TECHNICAL NOTE

DATE:	06 October 2022	CONFIDENTIALITY:	Public
SUBJECT:	WSP Response to EA Comments		
PROJECT:	Bognor Golf Course Hydraulic Model	AUTHOR:	Andy Smith

INTRODUCTION

Table 1: 10.25hr 100yr Design Rainfall Depths

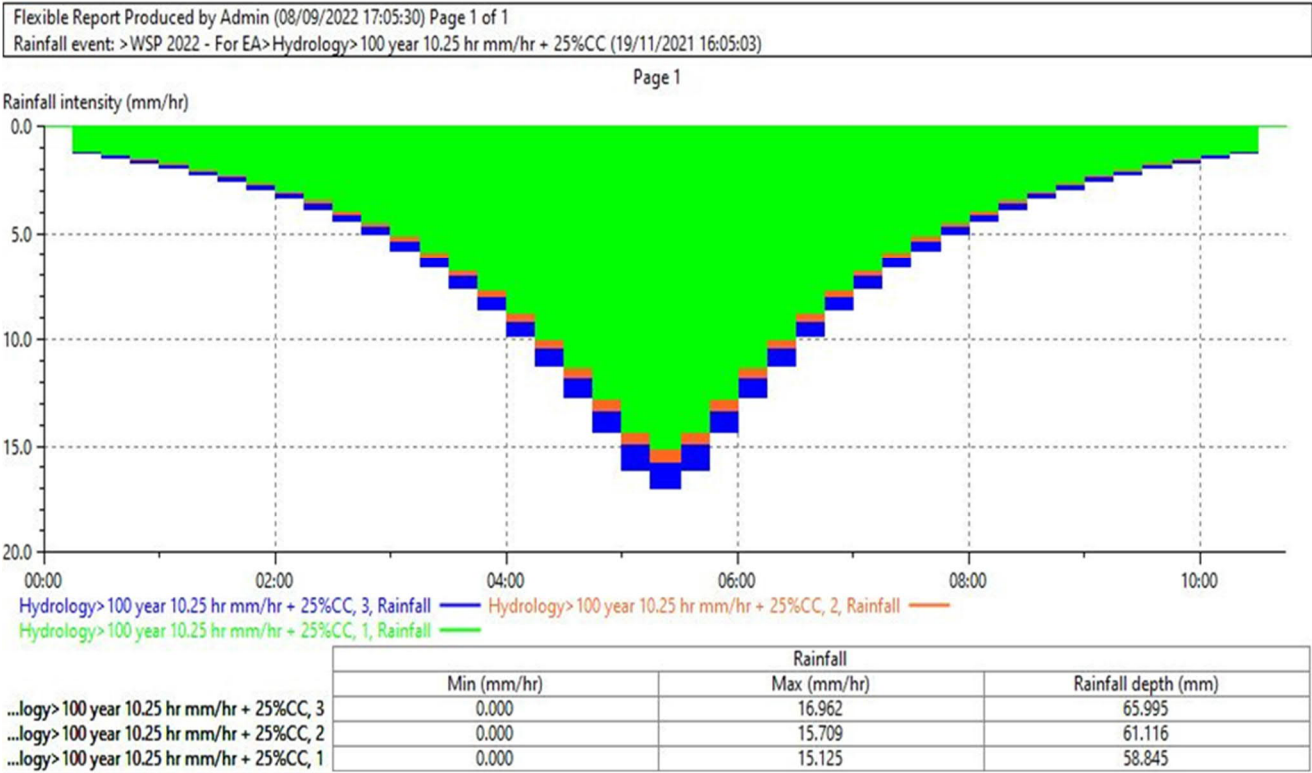
- An example rainfall hyetograph has been included in the hydrology report (figure 4). In addition, a table is presented in table 4 which presents the revised rainfall depths. The rainfall hyetographs and depths presented in the hydrology report were compared against the rainfall data for the 100 year 10.25 hr mm/hr+25%CC scenario included within the Infoworks Model. There appear to be differences between the rainfall applied within the hydraulic model and the rainfall rate/depths reported within the hydrology report. Please clarify why there are differences.*

There are no differences between the rainfall within the hydraulic model and the rainfall reported within the hydrology report. The difference observed by the reviewer was caused by the data within the report being the current day scenario (i.e. no climate change allowance) and that within the model being for the future scenario (i.e. with climate change) for ease of approval the table has been updated below and the extract from the model provided by the Environment Agency reviewer is also below, noting that in the image the rainfall depths are presented in the reverse order than those in the table.
